Accessibility Survey

City of Downey Little Lake Road & Florence Avenue

Date of Inspection
2/3/2017

Prepared By
Disability Access Consultants
(800) 743-7067

Sidewalks , Change in Level : Change in Level Non Beveled

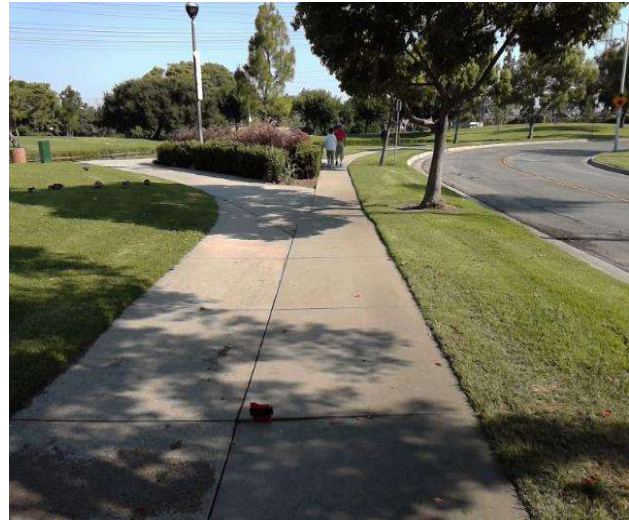
There is a change in elevation greater than recommended value.

On-Site Finding 0.50 inches

Ensure that the change in elevation is within the recommended value.

Sidewalks , Change in Level : Change in Level Non Beveled

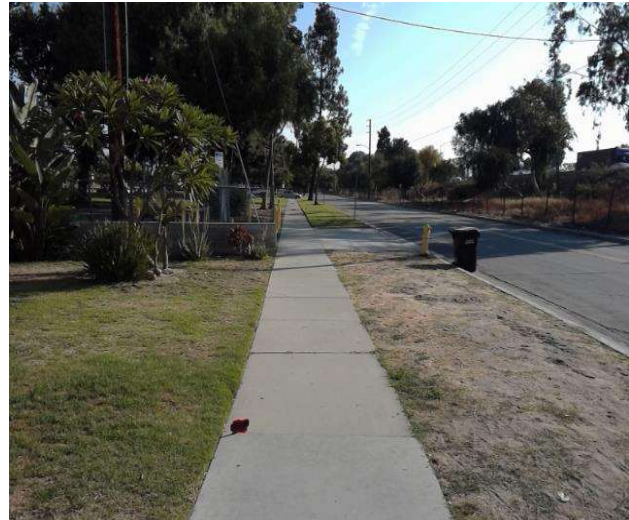
There is a change in elevation greater than recommended value.

On-Site Finding 0.37 inches

Ensure that the change in elevation is within the recommended value.
